#### **2.4.6 Roadway Realignment**

#### **2.4.8.3 Miller Children's Hospital–Pediatric Inpatient Tower, Utility Trench, and Central Plant Building**

**FIGURE R2.4.6-1**  
Central Plant, and Roadway Realignment

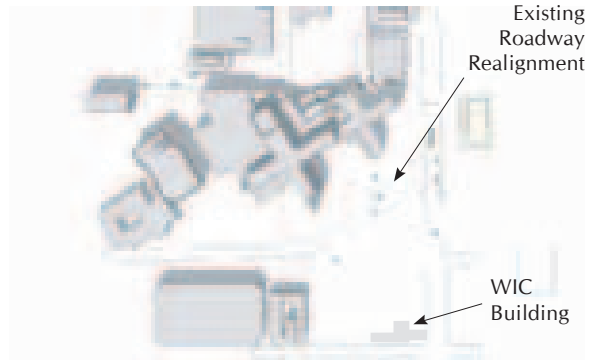
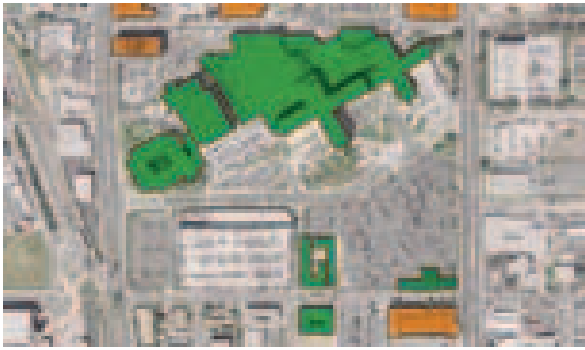
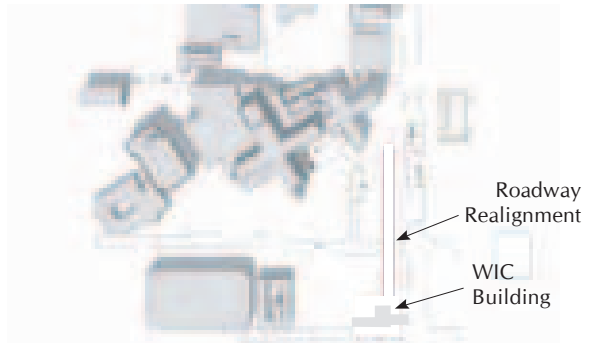
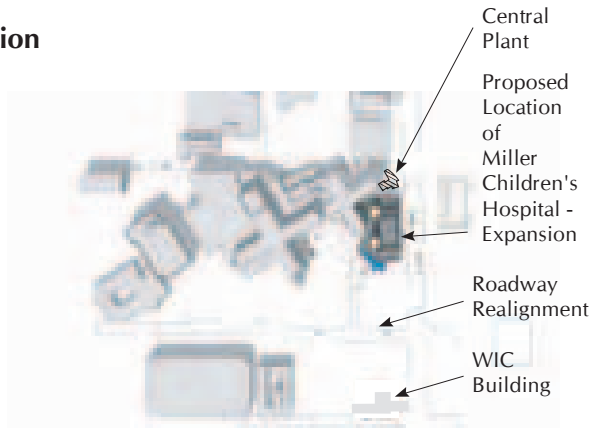
Page 2-12 The locations of the central plant building and utility trench, shown in Figure 2.4.6-1 as being northeast of the intersection of Atlantic Avenue and 27th Street, were revised in Figure R2.4.6-1 to reflect the proposed locations southwest of the intersection of Atlantic Avenue and Columbia Street.

In the first sentence of the first paragraph under this heading, please replace the reference to (Figure 2.4.6-1, *Central Plant, Utility Trench, and Roadway Realignment*) with the following:

(Figure R2.4.6-1, *Central Plant and Roadway Realignment*)

**FIGURE R2.4.8-1A**  
Construction Scenario, Step 1, July 2005 to October 2005

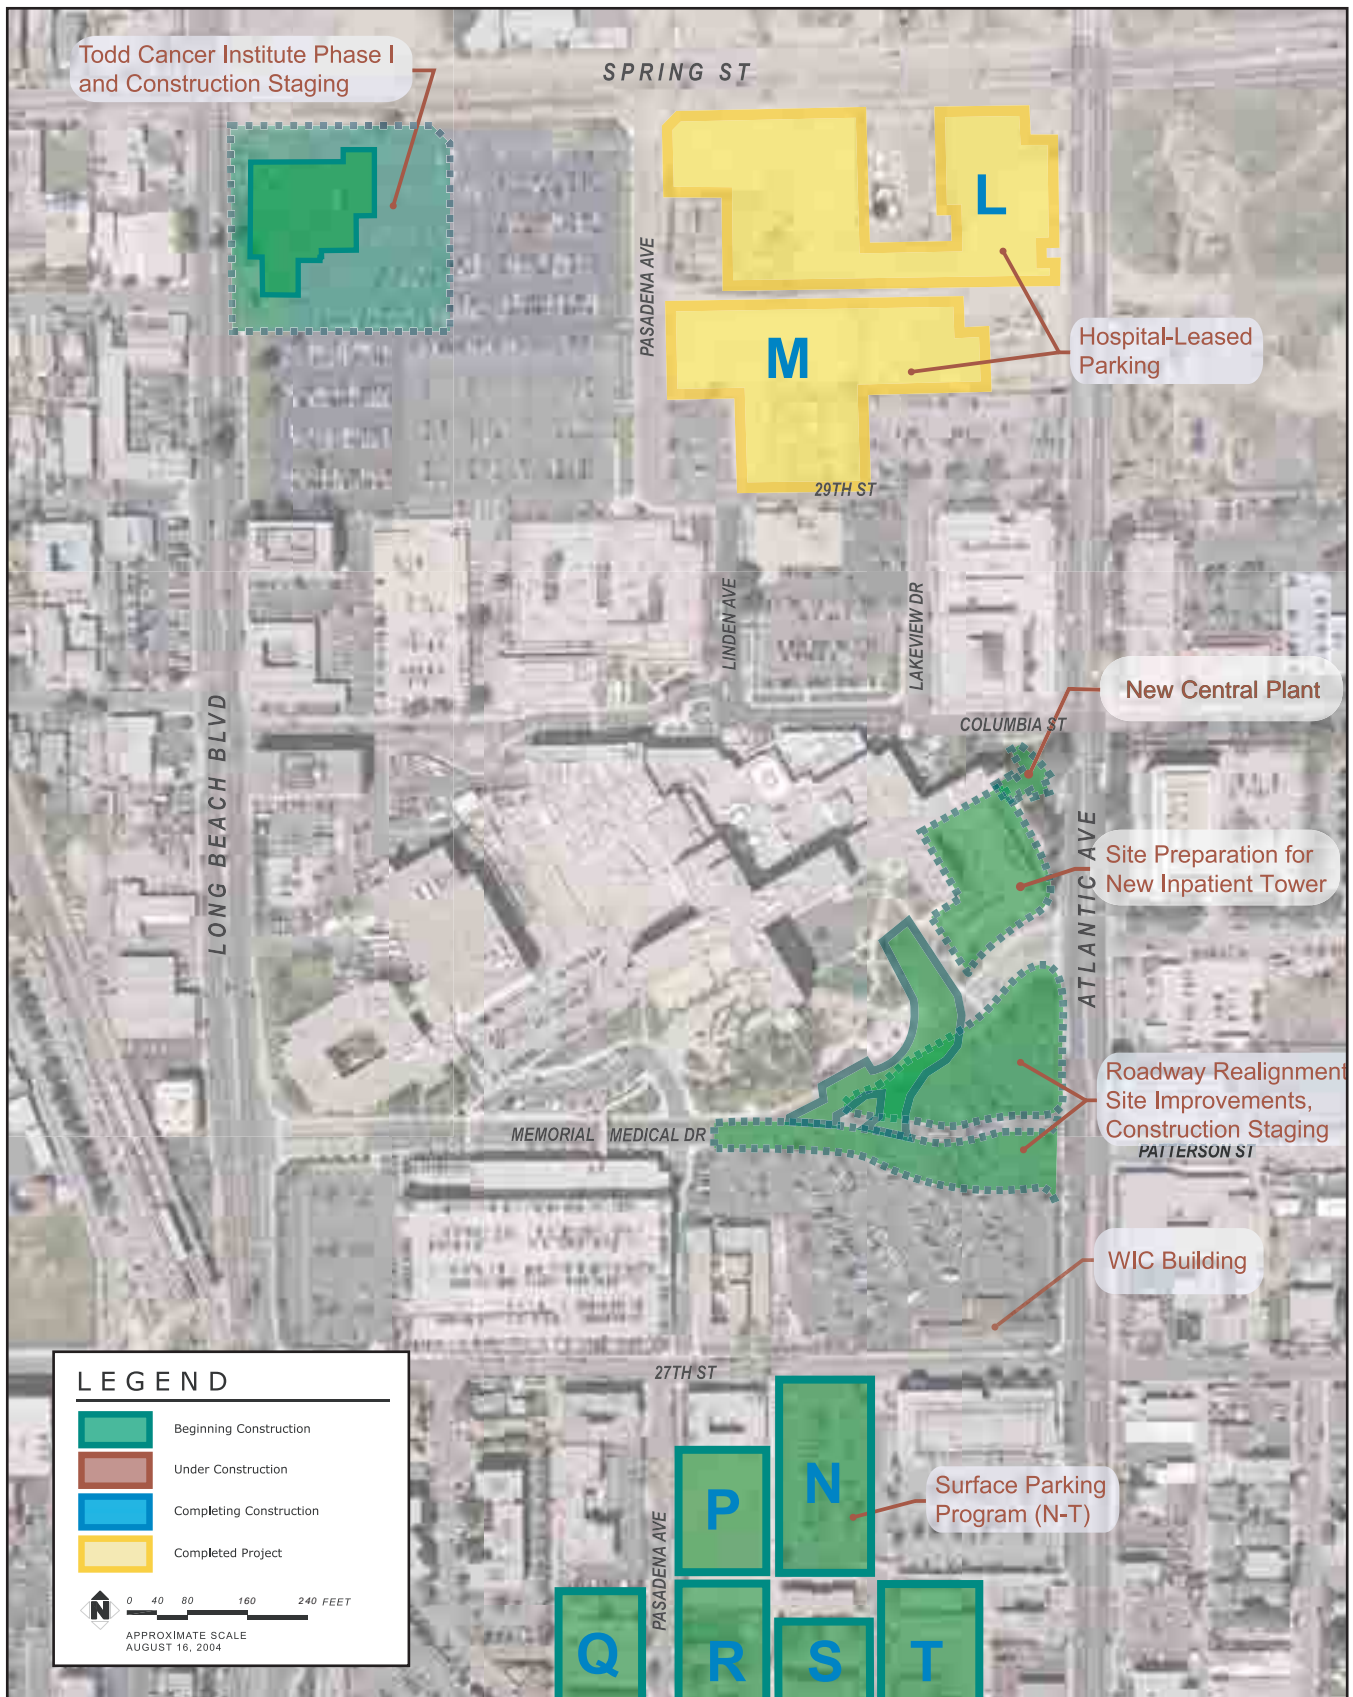
Page 2-13 The northeastern boundary of the Campus, the proposed location of the central plant building, and the conceptual footprint for the Todd Cancer Institute shown in Figures 2.4.8-1A through 2.4.8-1J were revised to reflect the corrected Campus boundary, revised location of the central plant building, and updated conceptual footprint of the Todd Cancer Institute as depicted in Figures R.2.4.8-1A through R2.4.8-1J.

Page 2-13 In the last sentence of the first paragraph, please replace the reference to (Figure 2.4.8-1A) with the following:

(Figure R2.4.8-1A)

**FIGURE R2.4.8-1C**  
Construction Scenario, Step 3, June 2006 to September 2006

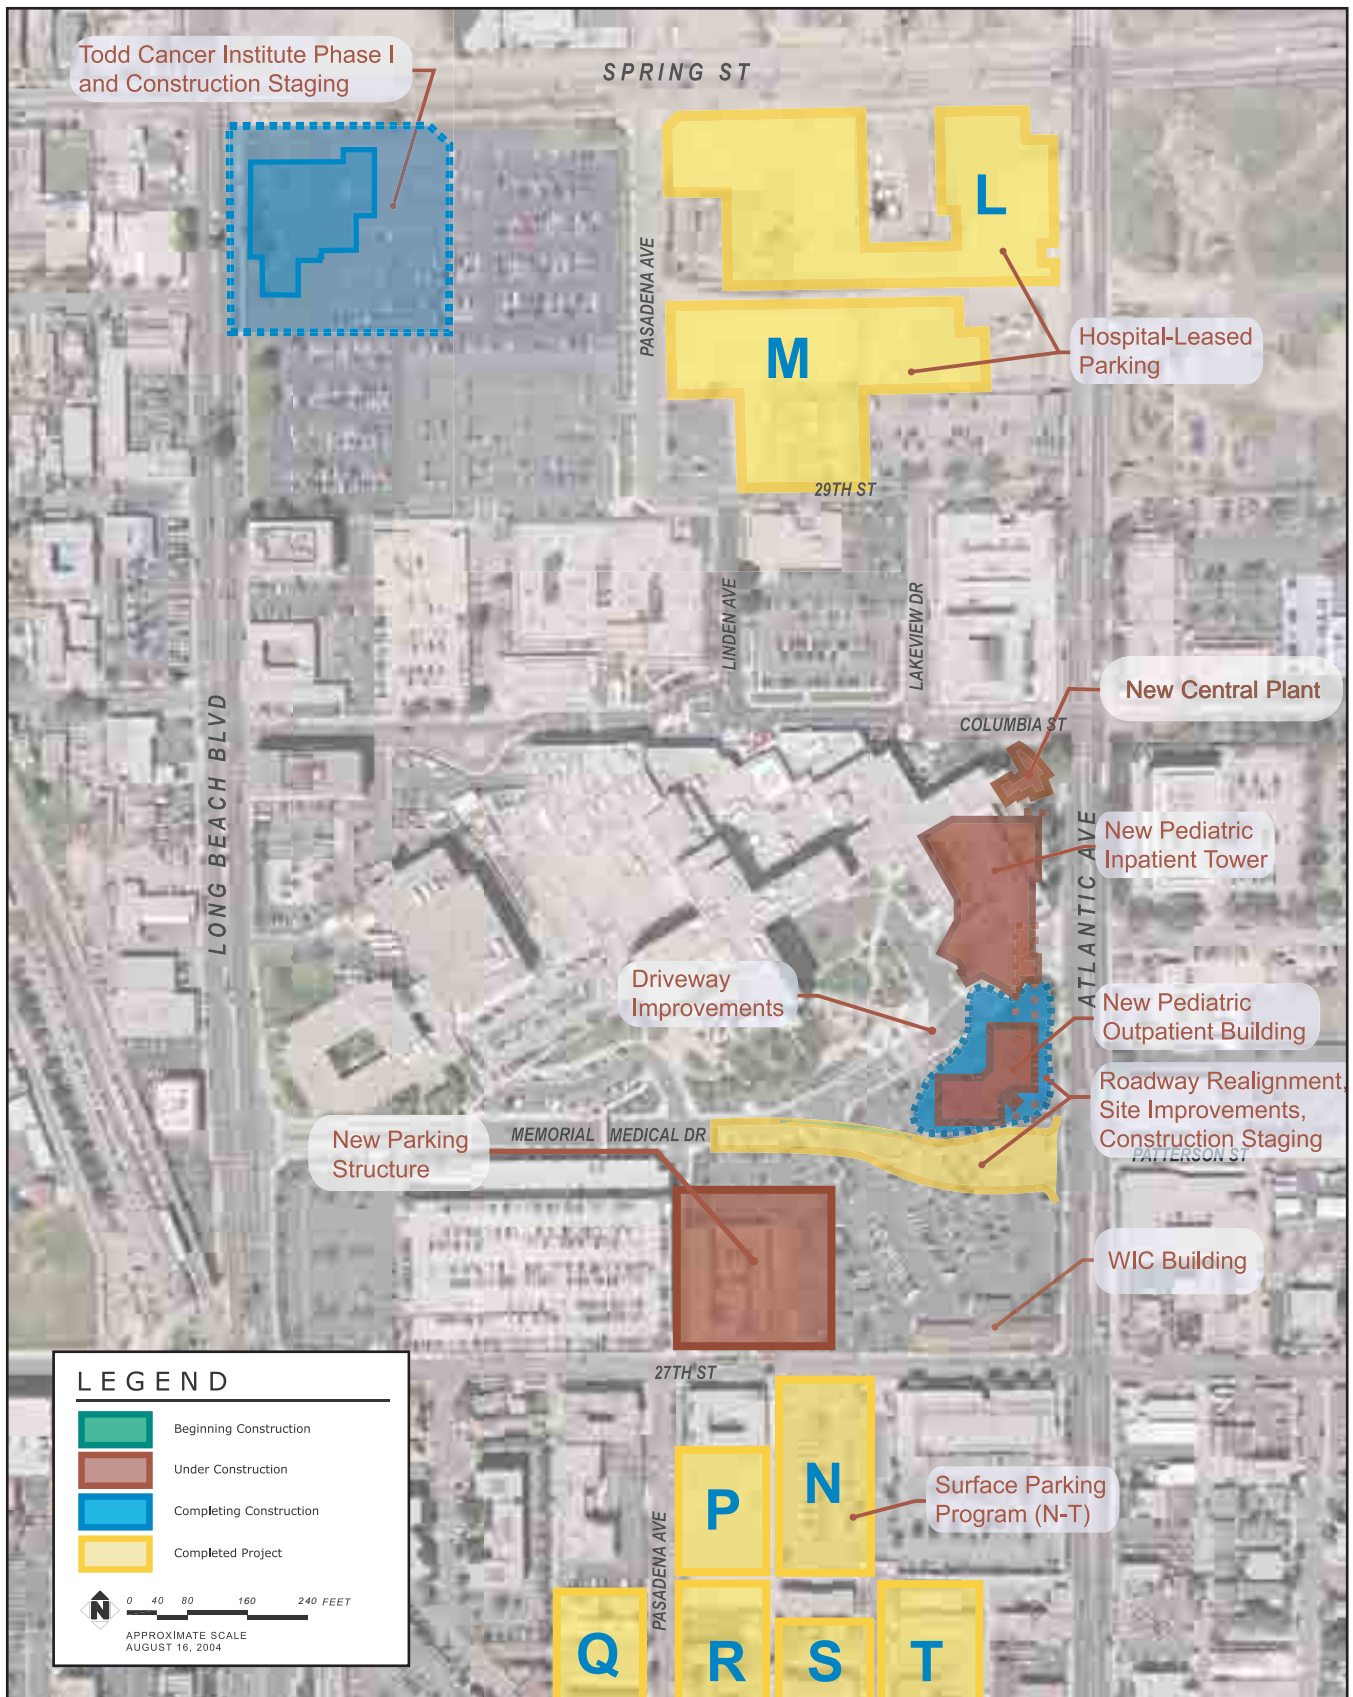
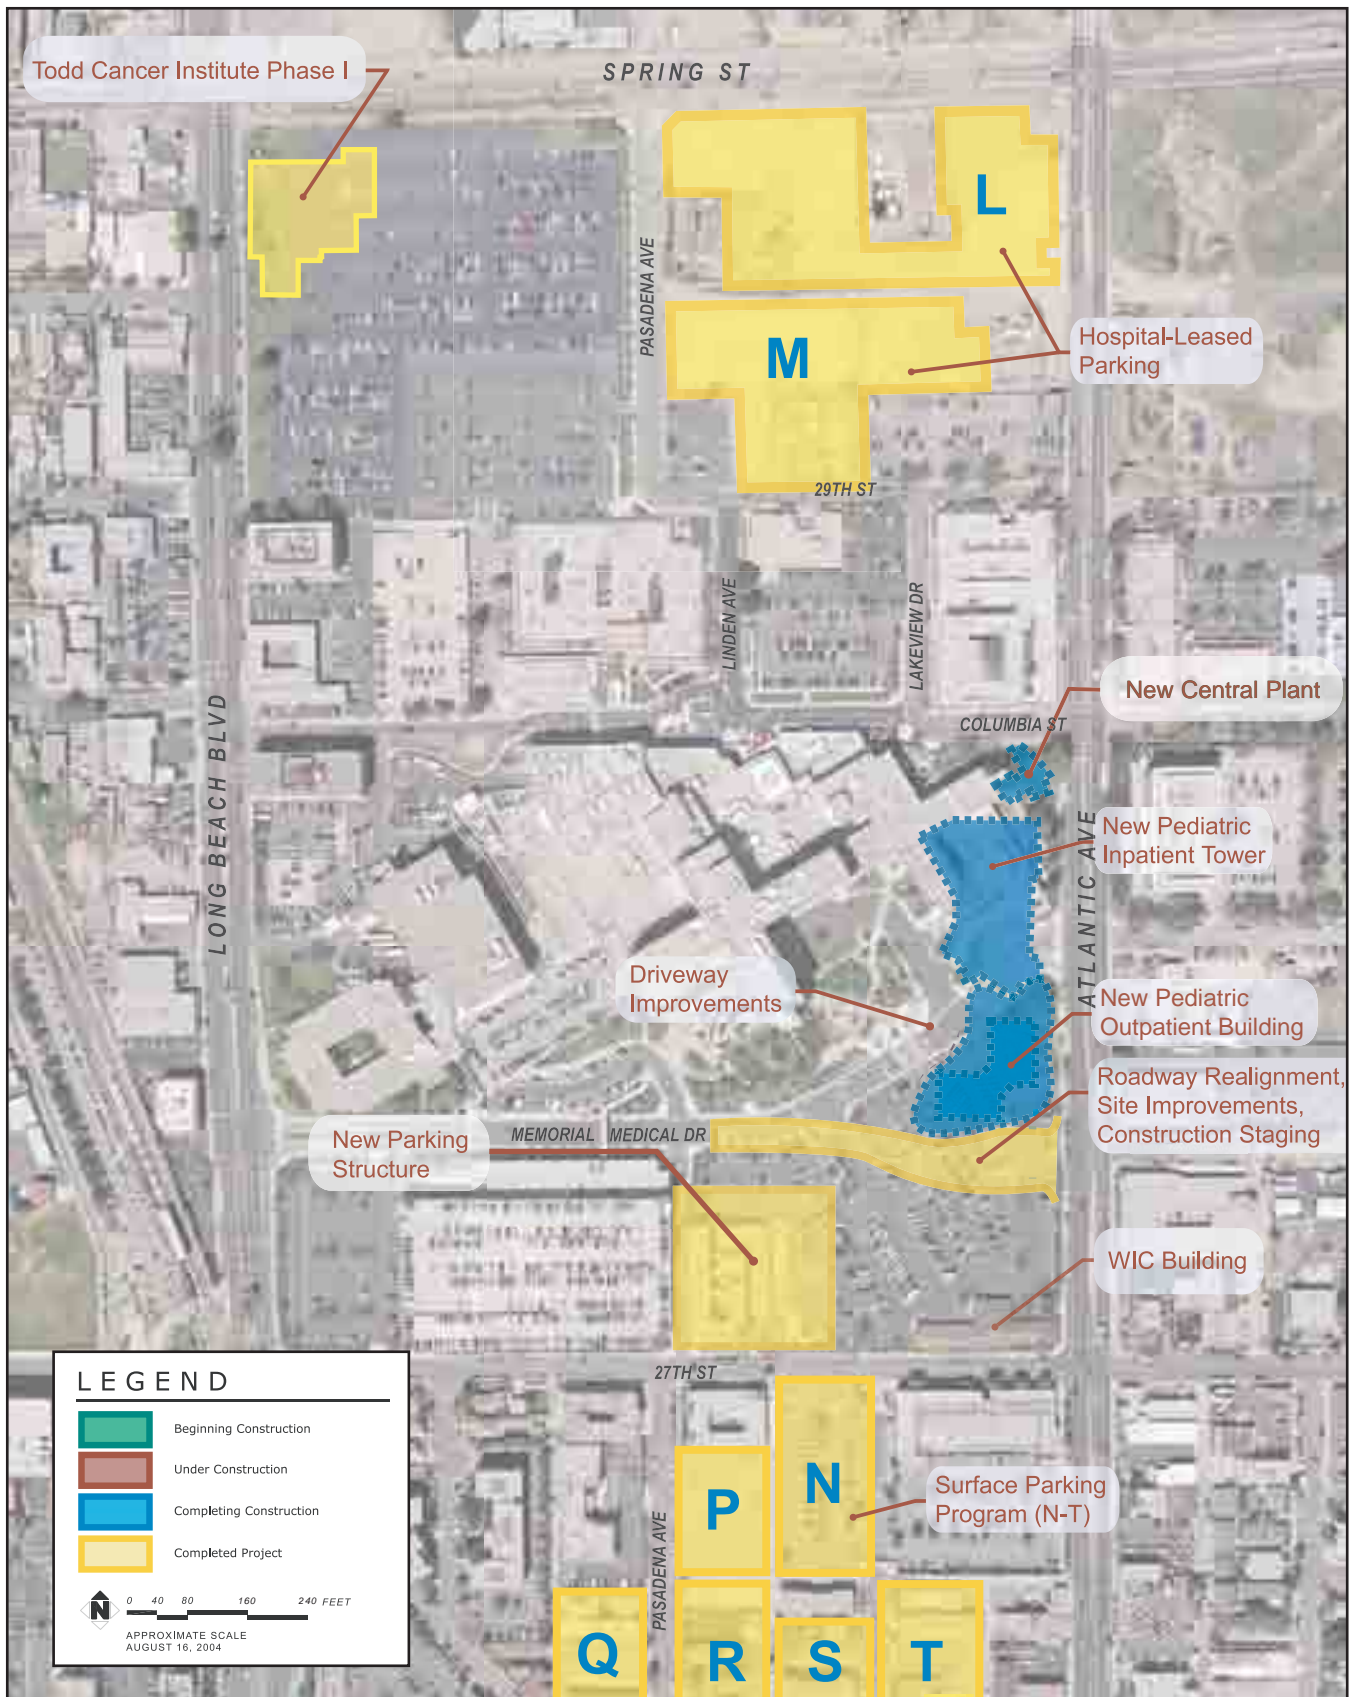
Page 2-16 In the last sentence of the second paragraph under this heading, please replace the reference to (Figure 2.4.8-1C) with the following:

(Figure R2.4.8-1C)
